## Colorado Springs, CO

### **Final Report - Corrections Required** **Application No. DEPN-23-0002**

**Description : proposing to build (4) 3-story apartment buildings with clubhouse and pool**

# VETERANS VICTORY - LOT 1 DEVELOPMENT PLAN

B. LAND DEDICATION FORMULA FOR COMMUNITY PARKS			
240	X	0.0049	= 1.18
NUMBER OF UNITS		ACRES OF DEDICATION PER UNIT	LAND DEDICATION REQUIREMENT ACRES

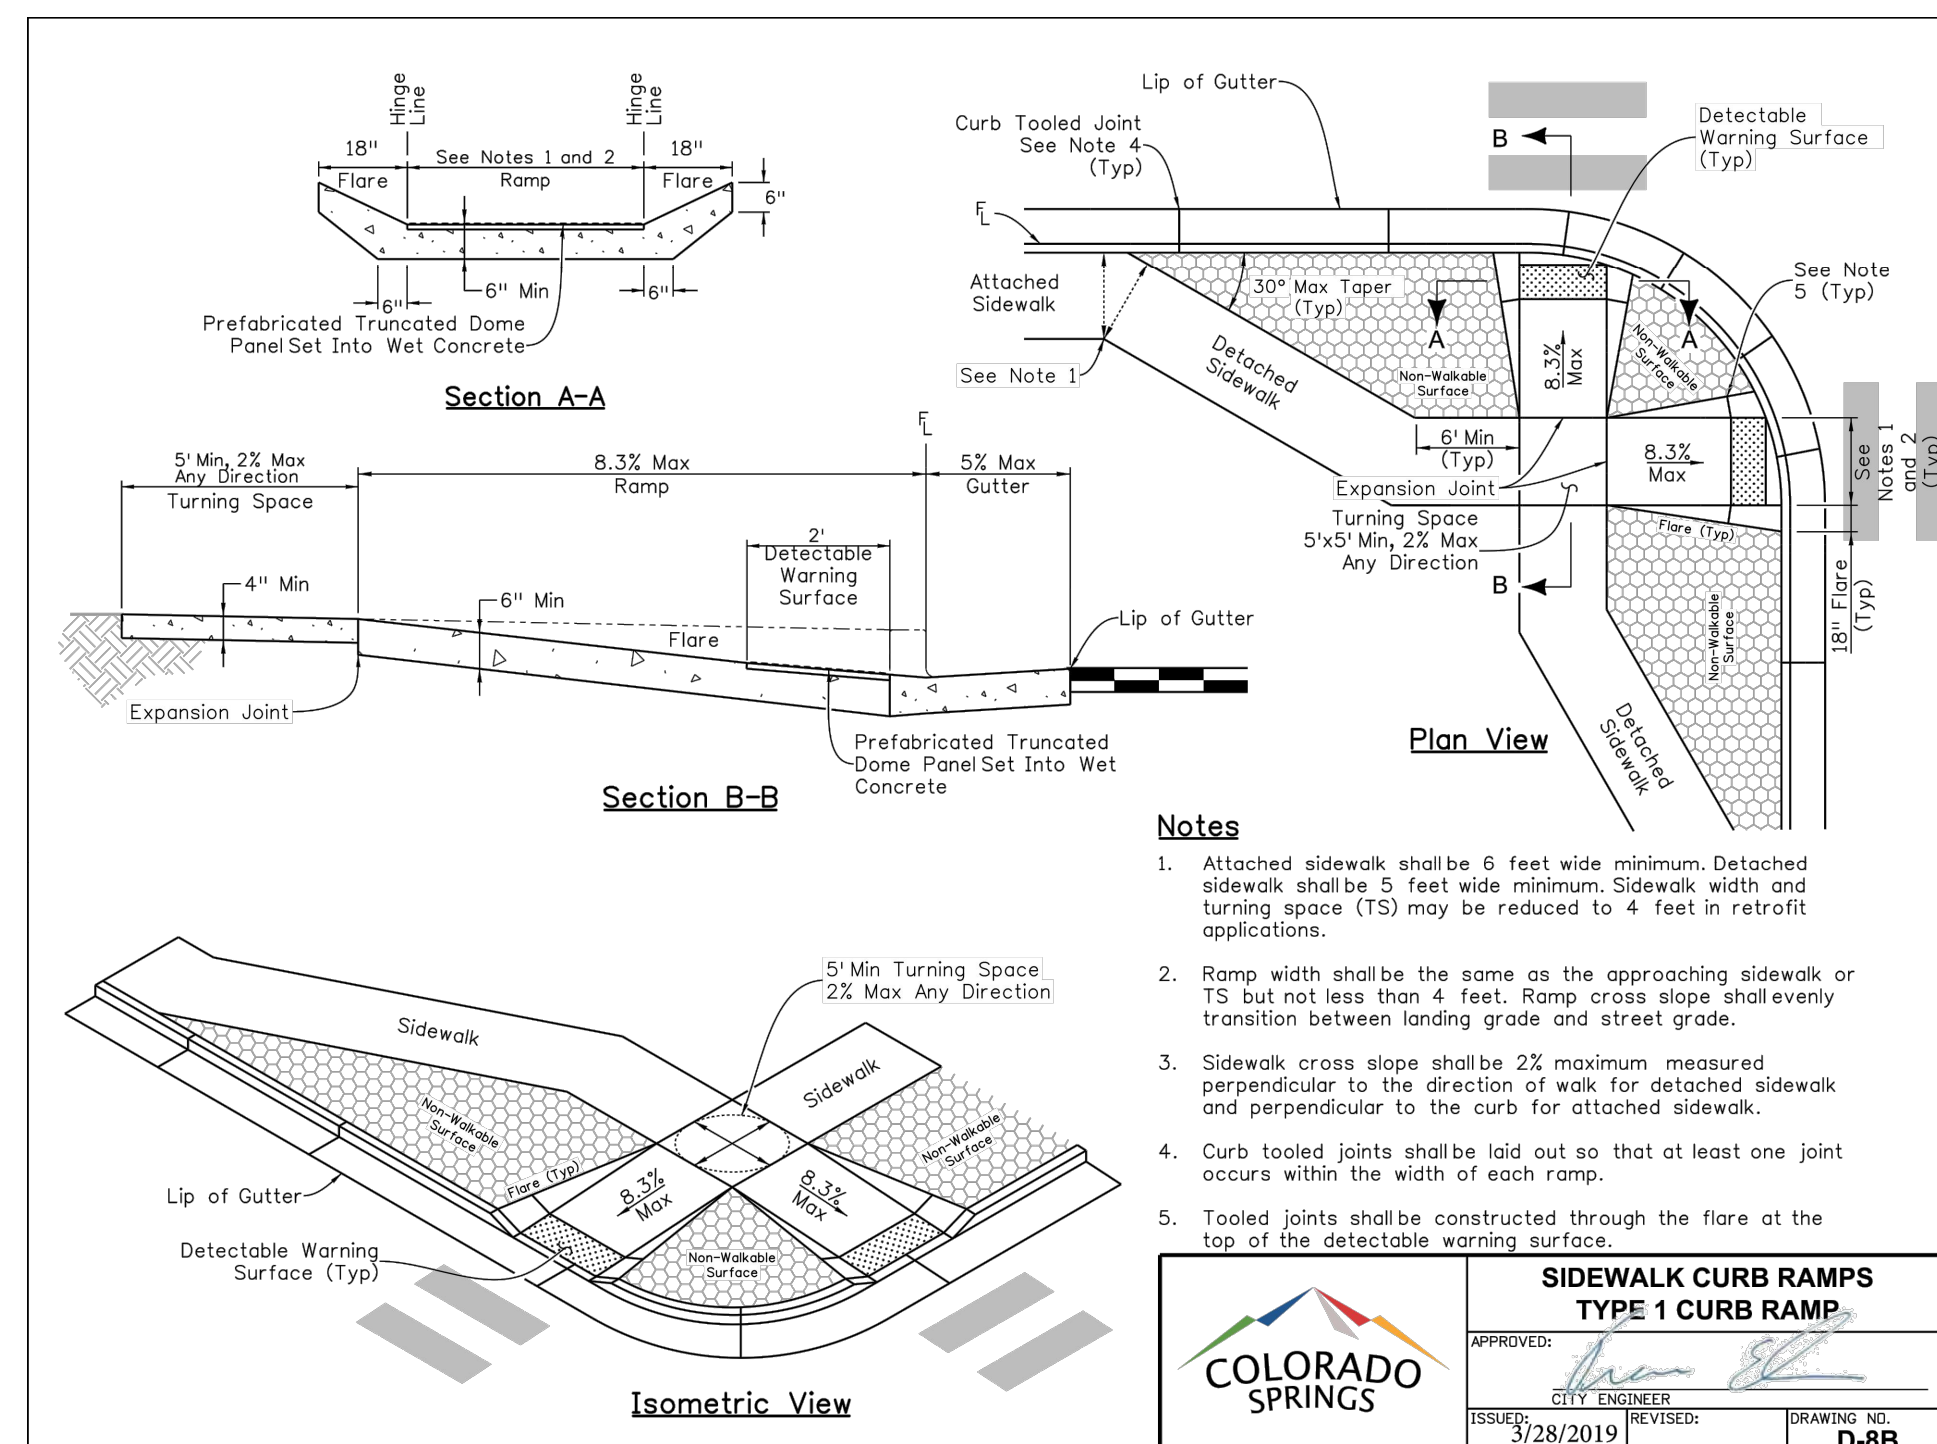
Add DEP-N-23-0002 to each page of the plan set

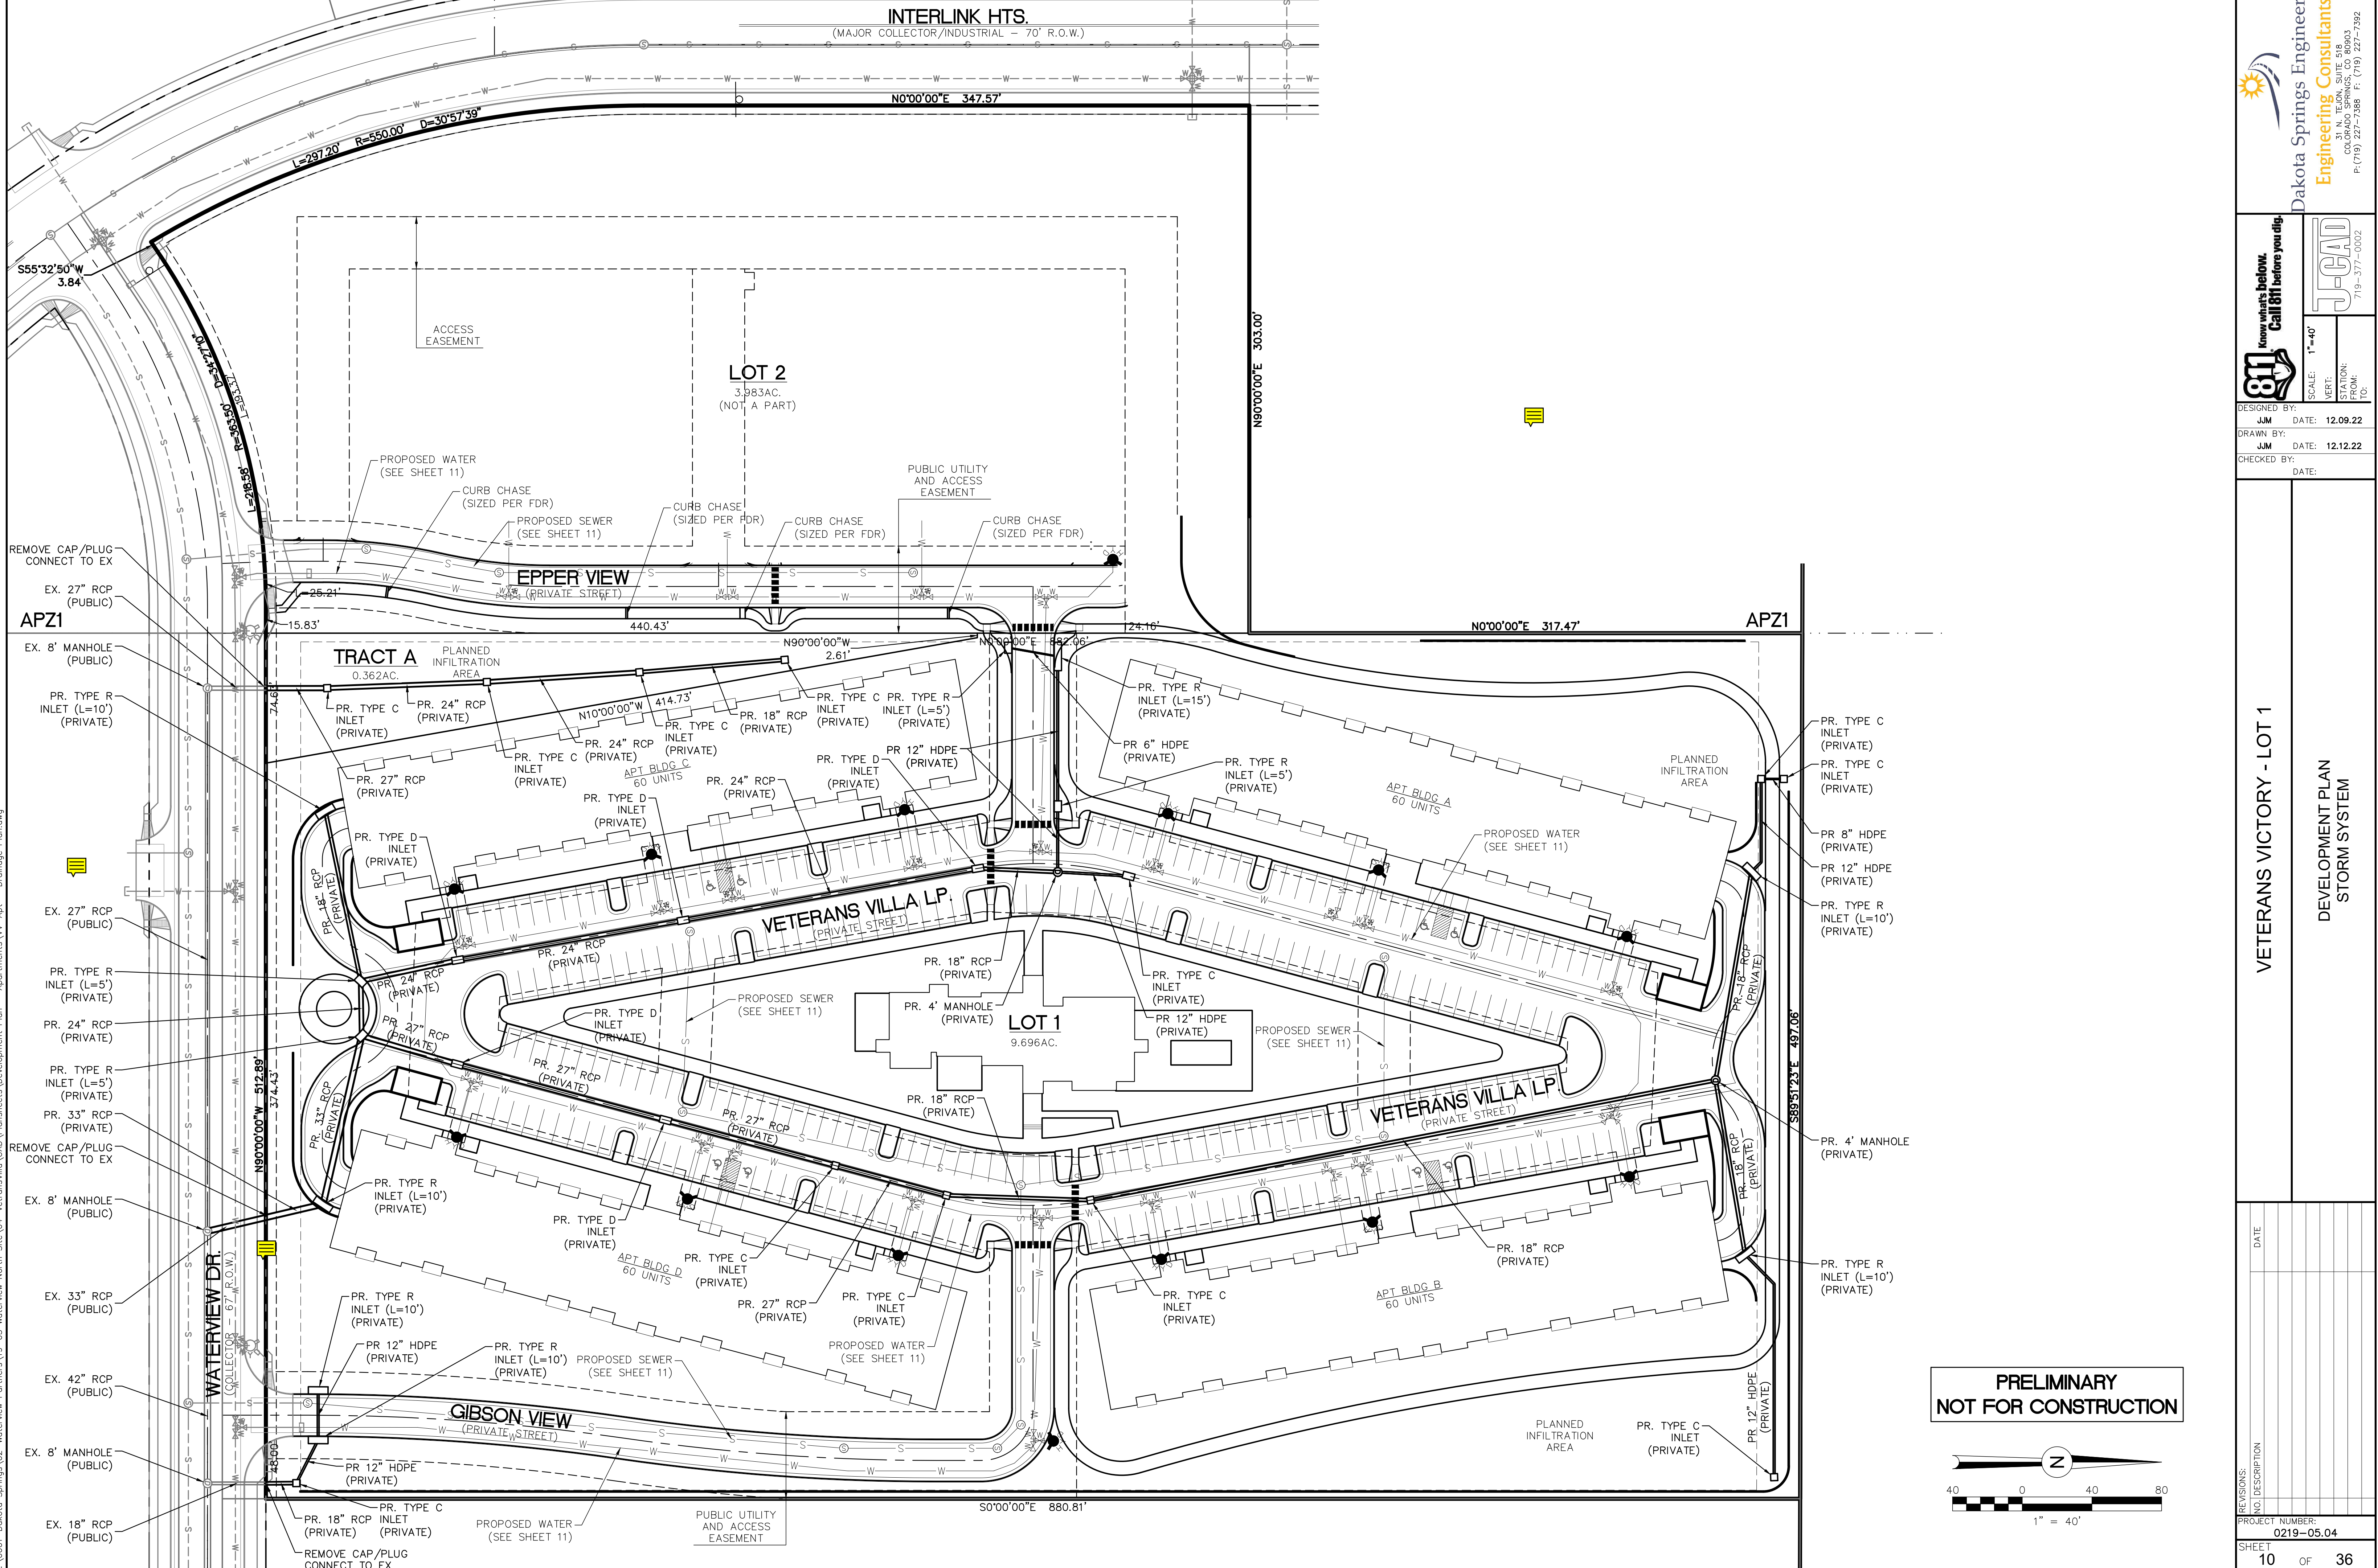
153	10	Jonathan Scherer : City Engineering - SWENT	Planned infiltration areas: Show the exact area from the FDR that is proposed on the Grading and Landscape plans. This needs to be shaded, textured coloured, etc. This is a global comment.
154	10	Jonathan Scherer : City Engineering - SWENT	33" and 27" pipes are not as common sizes. These are acceptable per the DCM, so this is an informational comment.
156	10	Jonathan Scherer : City Engineering - SWENT	There was no existing pipe shown here previously. Please verify this is correct.
143	11	Mike Gackle : Col Springs Utilities	An approved HGL response letter is required.
144	11	Mike Gackle : Col Springs Utilities	An approved WWMFF is required.
145	11	Mike Gackle : Col Springs Utilities	Final approval is contingent on the Annexation being approved.
146	11	Mike Gackle : Col Springs Utilities	Verify there is proper separation b/t FH & bldg.
147	11	Mike Gackle : Col Springs Utilities	Appears you will have a conflict with Storm and sanitary/manhole

**DEVELOPMENT PLAN  
PRELIMINARY UTILITY & PUBLIC FACILITIES PLAN**

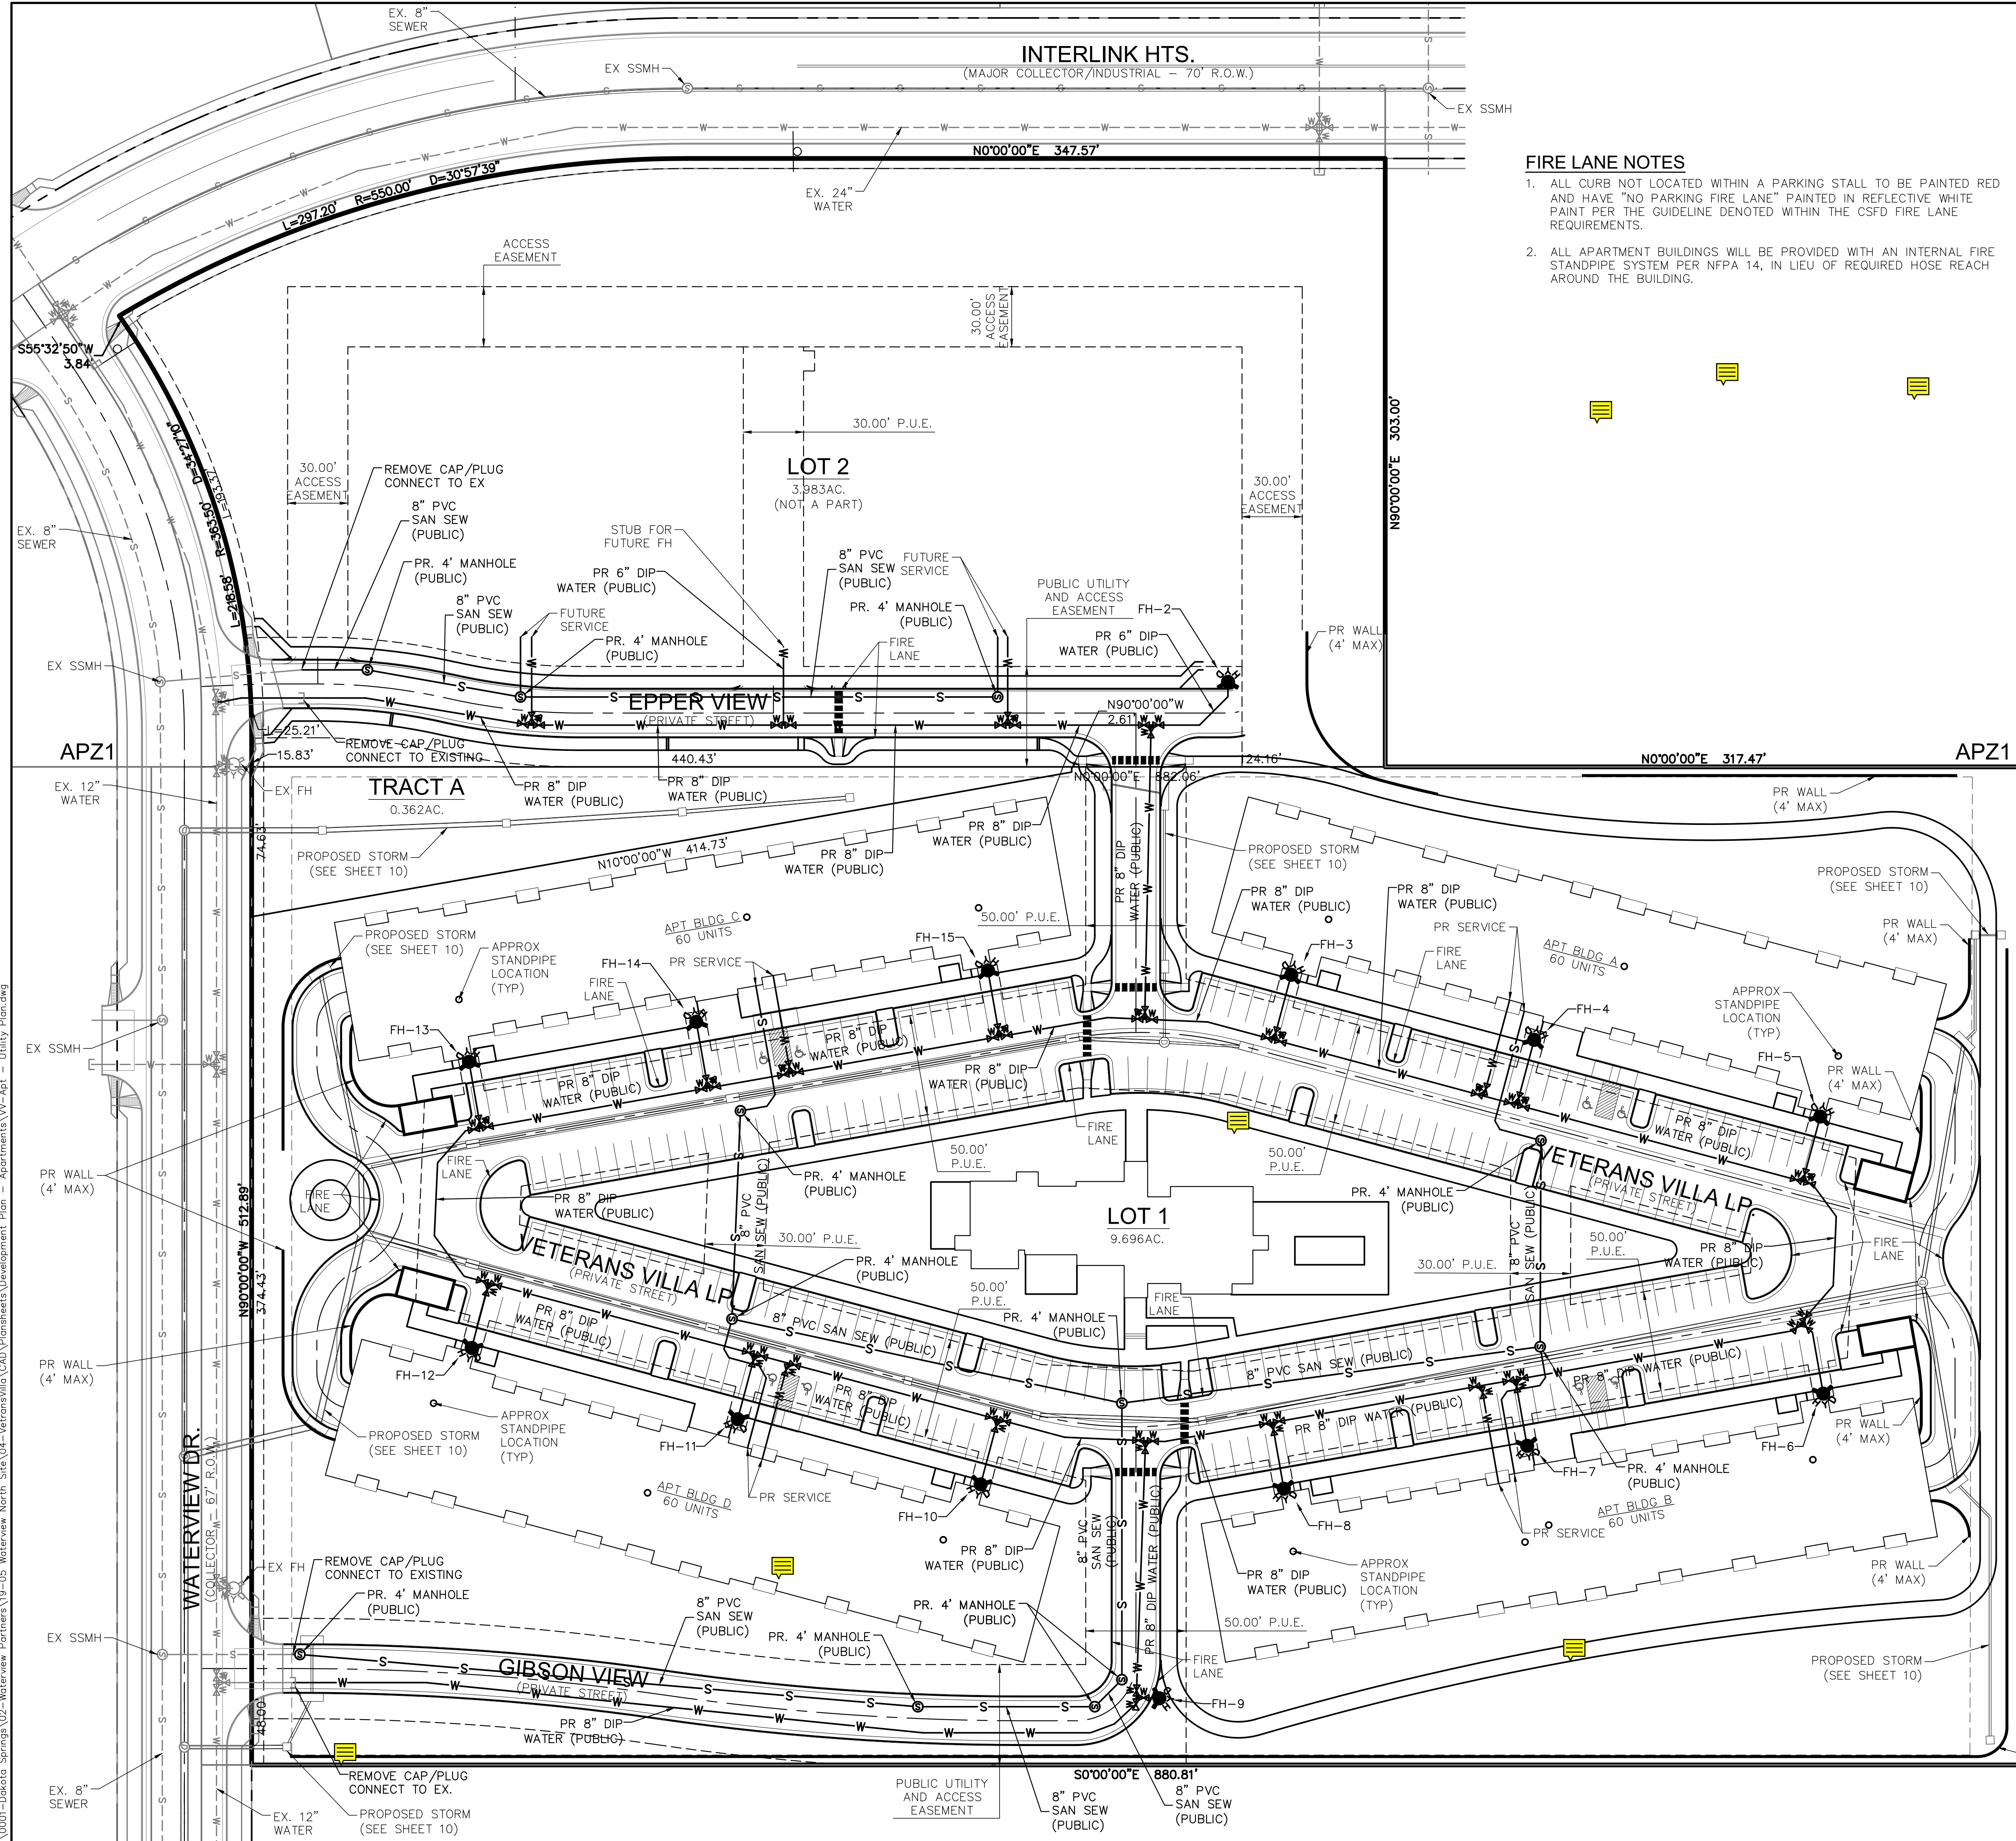
148	11	Mike Gackle : Col Springs Utilities	If the Fire Hydrants are not in an easement are they going to be Private?? If Public change the easement lines on this plan and the Plat.
149	11	Mike Gackle : Col Springs Utilities	Show and label all proposed services.
150	14	Mike Gackle : Col Springs Utilities	Show and label propose sanitary main
151	14	Mike Gackle : Col Springs Utilities	Show and label proposed water and wastewater mains and services on all Landscape Plans.
137	1	Caroline Miller : Planning	Please revise note to state: 'In reference to COPN-22-0002, PLDO obligations for this parcel will be met by fees in lieu of land dedication.'
138	1	Caroline Miller : Planning	CDI: Citywide Development Impact Fees for Police and Fire apply to all new and redeveloped residential and nonresidential development. This development is applicable to CDI and an estimate of PLDO, School, and CDI fees have been uploaded to this file and will be due at time of building permit.
